29 April 2026

<b>Title</b>	<b>PLANNING APPLICATIONS REPORT</b>
<b>Ward</b>	Thames
<b>Planning Application Reference:</b>	PL/24/0846/FUL
<b>Site Address:</b>	Napier Court Napier Road Reading
<b>Proposed Development</b>	Demolition of existing buildings and erection of new buildings of 11 storeys to provide 570 build to rent residential dwellings (Class C3) with residential amenity space, parking, landscaping and associated engineering works (amended description)
<b>Applicant</b>	Peveril Securities Ltd
<b>Report author</b>	Matt Burns, Principal Planning Officer
<b>Deadline:</b>	<b>Extension of time date:</b> 26 <sup>th</sup> February 2026
<b>Recommendation</b>	<p>REFUSE planning permission for the following reasons:</p> <ol style="list-style-type: none"><li>1. The proposed development, by reason of its failure to provide Affordable Housing either on or off-site via a completed legal agreement fails to address the housing needs of Reading Borough, contrary to Policies H3, H4 and CC9 of the Reading Borough Local Plan (2019), the Council's Adopted Supplementary Planning Documents on Affordable Housing (2021) and Planning Obligations under Section 106 (2015) and paragraphs 9, 11, 12, 39,

Figure 10 – Proposed land to be safeguarded for future MRT route

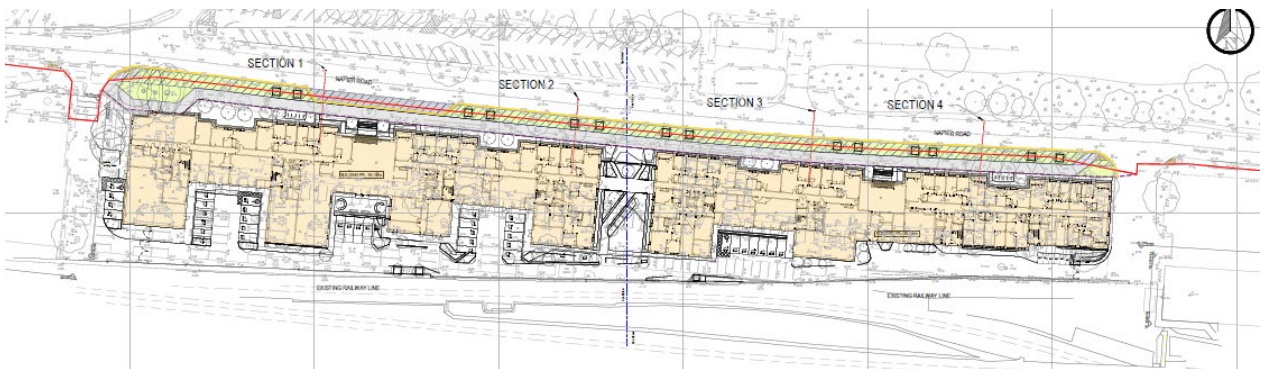
- 7.41 In this respect, the layout of the development proposes to incorporate a 3m wide strip of land to the front of the site between the proposed buildings and the Napier Road kerb line which is shown as free from built development, and which is proposed to be safeguarded for future MRT proposals. The proposed safeguarded land is shown as the hashed area in figure 10, together with zoomed in sections shows the eastern and western ends of the site frontage.

Figure 12 – Proposed pedestrian crossing

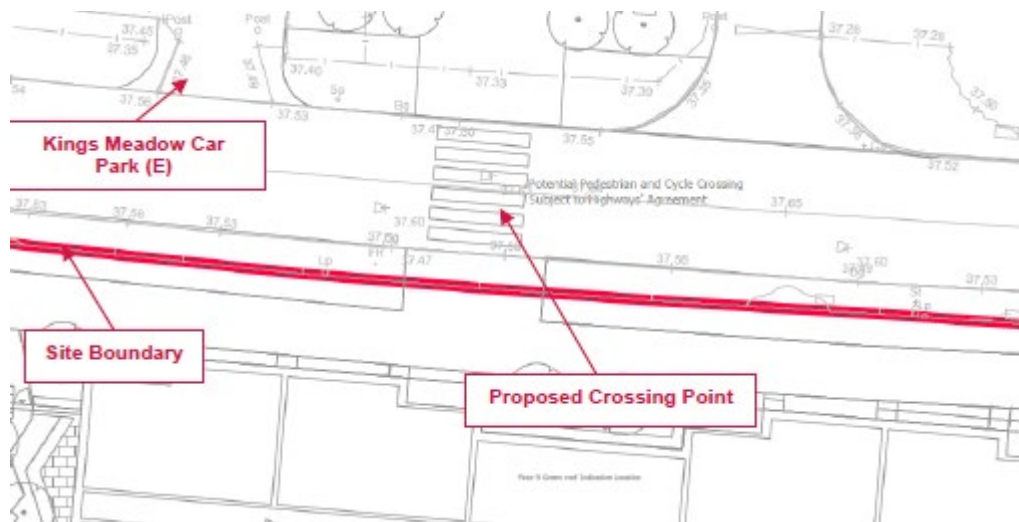
7.44 Notwithstanding the above, in terms of pedestrian permeability, the development also proposes to provide a new pedestrian crossing on Napier Road to improve connectivity to Kings Meadow located directly opposite the site which is one of the major areas of Public Open Space within the Borough. Kings Meadow is very likely to be the primary area of public open space used by occupiers of the proposed development. There is no pavement to the north side of Napier Road opposite the application site and therefore the proposed pedestrian crossing would link directly into Kings Meadow. On the south side of Napier Road the crossing point would be accessed from the footway in front of Block C of the proposed development as shown in figures 11 and 12 below.

- 7.45 The principle of a new pedestrian crossing in the general location as proposed in the location above by the applicant is generally supported by RBC Transport and Leisure/Parks Officers. The full detail of the crossing design and connection into Kings Meadow is required to be submitted and agreed as part of the s106 agreement and also requires the developer to enter into appropriate highway works agreements to provide the crossing prior to occupation of the development in accordance with an approved specification. The proposed pedestrian crossing would be a significant benefit of the proposed development providing direct access to Kings Meadow Public Open Space and facilities within and facilitating a more direct route to access the Thames Path along the River Thames further north within Kings Meadow. This is considered of particular benefit given the current limited formal crossing opportunities on Napier Road to access Kings Meadow. The proposed crossing would align with criteria ii) of Policy CR11 in the development facilitating greater pedestrian permeability as well as Policy EN10 (Access to Open Space) which requires that in areas with relatively poor access to open space facilities (including as a result of severance lines), new development should make provision for, or contribute to, improvements to road and other crossings to improve access to green space and/or facilitate the creation or linking of off-road routes to parks.

Figure 21 – Proposed development within Napier Road street-scene.

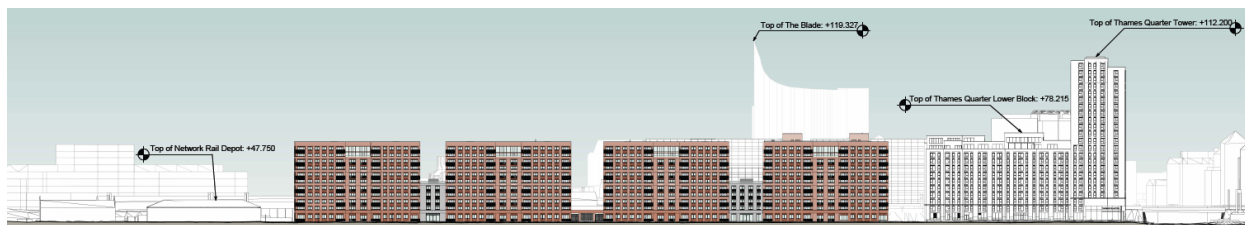
7.60 As can be seen in figure 21 above the 11 storey building height would be set just below the 12 storey height of the lower shoulder element of the adjacent Thames Quarter building to the west. The taller tower element of Thames Quarter is 23 storeys in height. Unlike the application site, Thames Quarter is located within the Station Area Tall Buildings Cluster which is one of three defined areas within the Central Area that are considered appropriate to accommodate tall buildings. This is defined by Policy CR10 which is clear that tall buildings will only appropriate within these specific areas. The application site is not located within a tall building cluster and therefore is not considered appropriate for tall buildings. Policy CR10 defines a tall building as 12 storeys for residential development and therefore the proposed development at 11 storeys is not considered a tall building in the context of the Local Plan (2019) but is the maximum storey height of a building that could be considered appropriate outside of the defined tall building cluster areas. When originally submitted, the planning application did propose Block A, located closest to Thames Quarter, at 12 storeys and therefore a 'tall building' (with blocks B, C and E at 11 storeys). Officers highlighted the clear conflict of the 12 storey element with Policy CR10 to the applicant and amended plans were submitted resulting in the current proposals which present a consistent 11 storey building height. It is pertinent to note that the above does not mean that a building of the maximum height appropriate for areas outside of the tall buildings area is automatically considered appropriate in terms of scale. It must be demonstrated in the context of the other relevant Local Plan policies that the development is appropriate, for instance, suitable architectural quality.

Figure 46 – Proposed soft landscaping

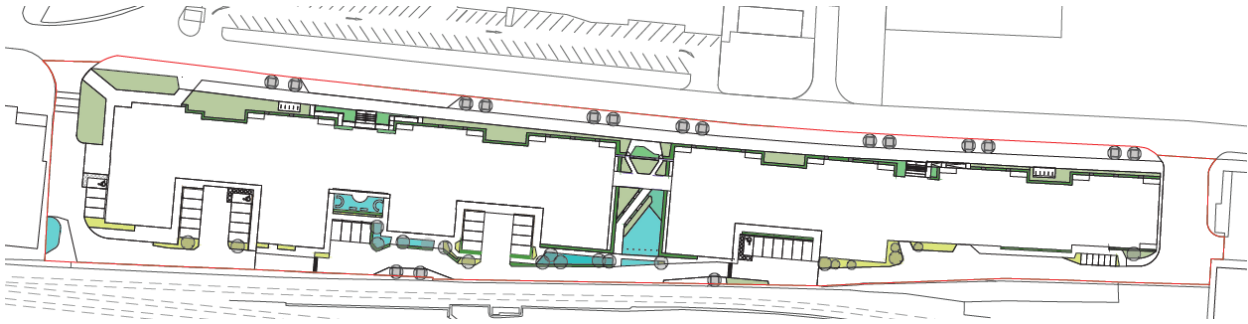
- 7.91 The soft landscaping proposals are shown in figure 46 below and consist of varied ornamental planting beds along the strip of the land and recesses to the front of the building as well as around the building entrances. A 1.7m high hedgerow is also proposed along the entire building frontage following the building's staggered footprint. The coloured dots in figure 47 below show proposed tree planting to the frontage which includes 16 trees of 2 species (*Amelanchier arborea* 'Robin Hill' and *Cornus kousa varchinensis*). Whilst trees are supported in this location, the RBC Natural Environment Officer raises concern over the proposed species which are relatively small and would be dwarfed by the scale of the proposed building. It is considered that taller and narrower trees would be required in this location to provide meaningful softening to the visual impact of the development. In terms of existing trees 6 'B' category trees (of moderate quality), 4 'C' category (of low quality) trees are proposed for removal to the Napier Road frontage to accommodate the proposed development, as well as full and part removal of 2 'B' category groups and 1 'C' category group (a mixture of beech, alder and birch, rowan and English oak species). 5 'B' category protected trees (all Norway Maples) located at the western end of the site frontage are proposed to be retained as part of the development. Loss and retention of existing trees is considered in the Natural Environment Section of this report below.

proposals ever come to fruition then the trees along this strip of land would be lost. Therefore, this planting to the MRT strip of land cannot be considered on the basis of retention in perpetuity but would provide visual mitigation for the length of time it would remain in place.

Figure 51 – relationship of proposed Block C and D within Napier Road

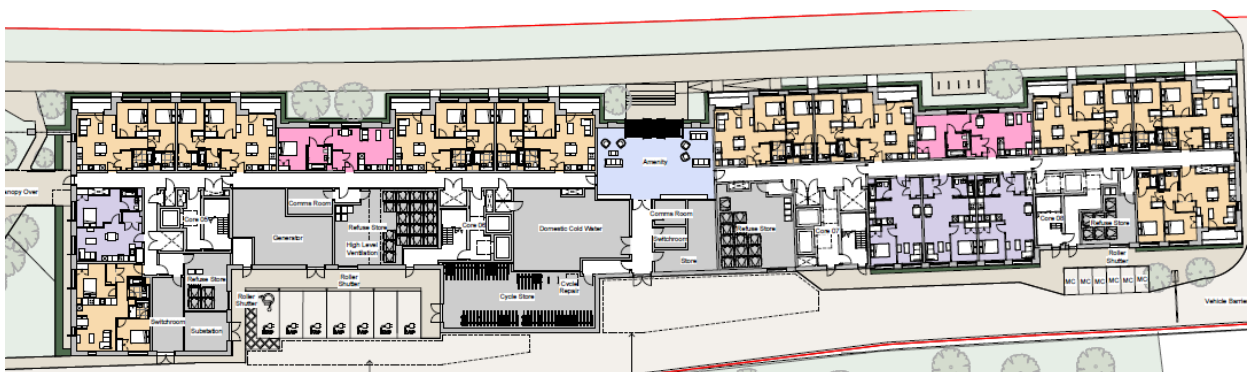
- 7.123 Figure 51 below also shows the relationship of blocks C and D with Napier Road where there is limited set back of a number of ground floor flat windows from the footway cycle way that would run along the front of the building. As can be seen in the figure some flats notably to Block C (left hand side of the figure) would - apart from a narrow hedgerow - directly abut the edge of the footway cycleway. Aspect on to the footway/cycle way would be the only outlook for some of the ground floor units which is likely to result in potential for loss of privacy to these units from passing pedestrians and cyclists and poor outlook for occupiers. This situation affects units to the ground floor of Block C and further evidences that the proposals would be an overdevelopment of this part of the site and provided inadequate space between the front of the building and Napier Road to accommodate the proposed building, infrastructure and landscaping requirements of the development. The set back from the edge of the footway/cycle way increases to a minimum of 1m to block D shown on the right hand side of the figure 51 below and a more spacious relationship with the front of the site is provided for Blocks A and B.

Figure 52 – Existing (left) and proposed (layout) in relation to TPO trees

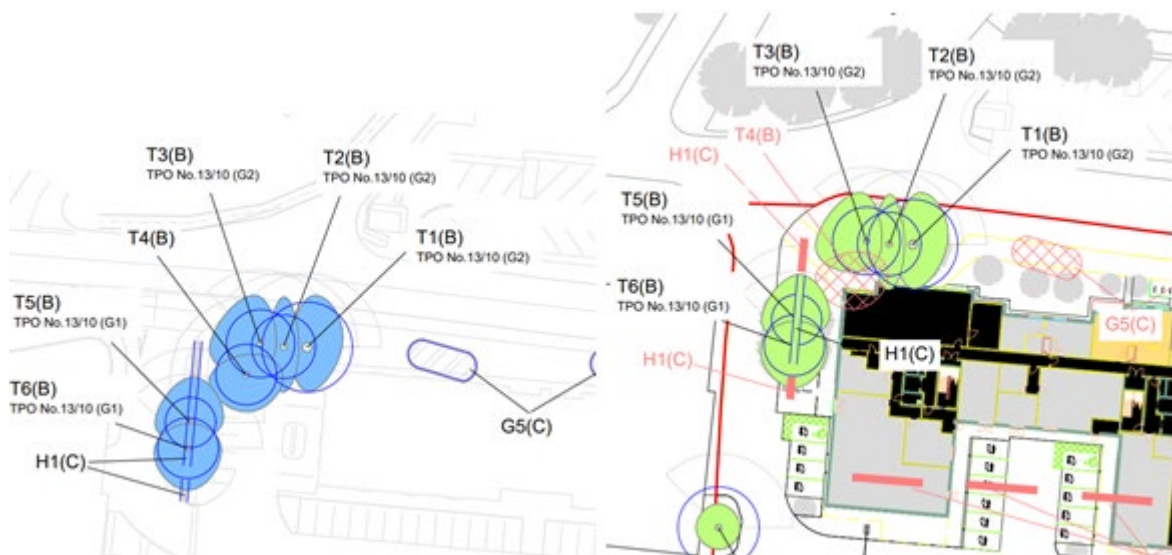
- 7.155 The 5 protected trees at the western end of the site are proposed to be retained as part of the development. In relation to these trees the applicant's AIA states that a new 'tree friendly' path will be constructed with the root protection areas (RPAs) of the trees as part of the hard and soft landscaping for the development and to provide a pedestrian route around the perimeter of the building, the feasibility of which is unclear, that 'facilitation pruning' would be required to each of the TPO trees to allow sufficient room for construction purposes and overall crown reduction proposed to create a sustainable relationship between the trees and building. As shown in figure 52 below the proposed building would be located closer to these trees than the existing small two storey office building.

- 7.156 The RBC Natural Environment Officer considers that western elevation of Block A of the development is located too close to these trees, as evidenced by the need to carry out facilitative pruning during construction, a crown reduction to improve the relationship, and there is likely to be further pressure to prune them in the future, to the detriment of their long term health or fell, to the detriment of the street-scene. The applicant was advised of the conflict with these trees at pre-application stage and also application stage but has not adjusted the building layout in order to provide sufficient room within the site or provide any adequate justification or mitigation for officers to be satisfied that the trees would not be harmed, directly or indirectly as a result of the proposed development. The RBC Natural Environment Officer also raised concern as to the accuracy of the RPAs that have been drawn for the TPO trees within the AIA given they are drawn as circular RPAs, incorporating the foundations of the existing building, whereas good arboricultural practice advises to adjust RPAs to omit areas where roots are unlikely to have proliferated (therefore these appear representative rather than accurately plotted).. Notwithstanding this, based on the proposed RPAs which would appear to abut the closest elevations of the proposed building, it is considered that the foundations required for this part of proposed Block A would be very likely to impinge on the RPA area and result in further harm to the health and long term survival of these protected trees.
